## Section 7: Spent Fuel Pool Integrity Evaluation

### 7.1 Scope of the Seismic Evaluation for the SFP

Figure 7-1  
Basic Process for Evaluation of Potential Failures for SFP Penetrations

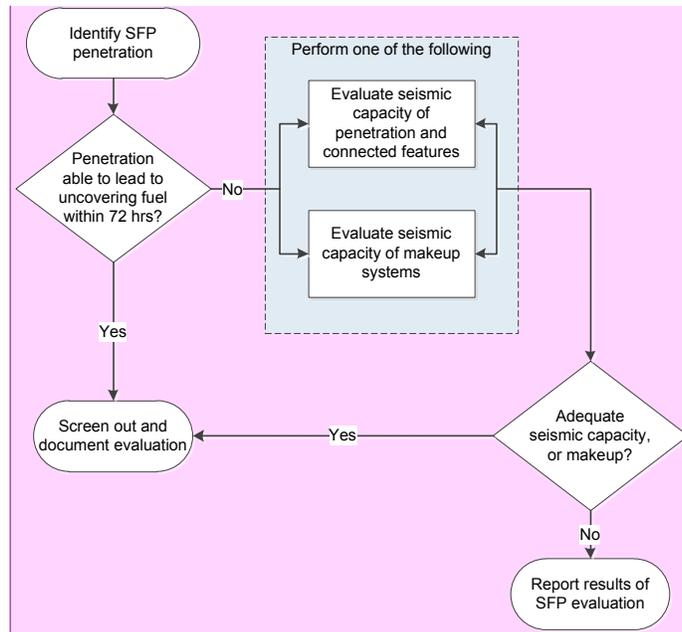
**Comment [AK11]:** The first set of yes and no are reversed. The arrows go both ways between the “perform one of the following” box and the “adequate seismic capacity” diamond. The arrows going into the box should be removed.
